TPL7407 OUTn negative voltage waveform at step motor driving

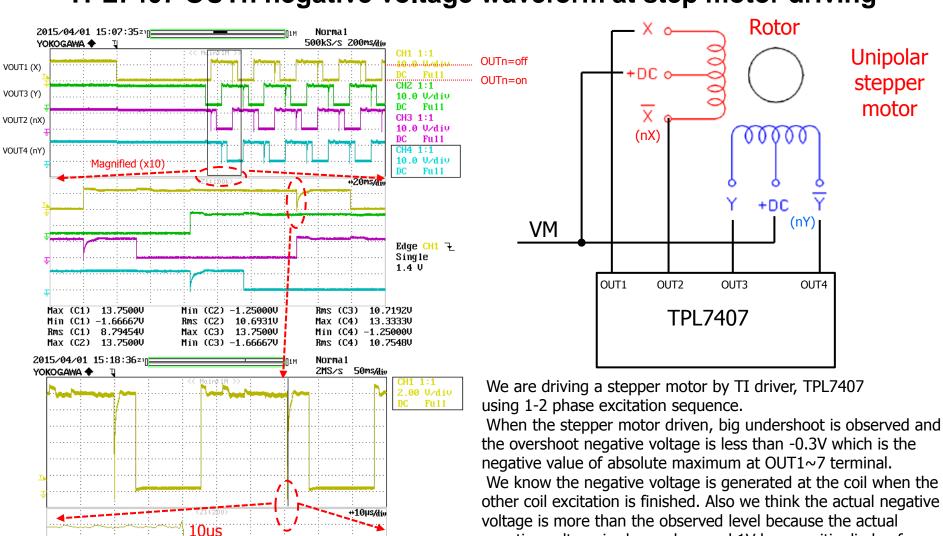
We know the negative voltage is generated at the coil when the other coil excitation is finished. Also we think the actual negative negative voltage is clamped around 1V by parasitic diode of

NMOS of TPL7407 OUTn driver.

Our question is whether this negative voltage breaks TPL7407 or not and whether the voltage affects any problem on TPL7407. If the answer is yes, is there any solution to reduce the negative voltage to safety voltage level.
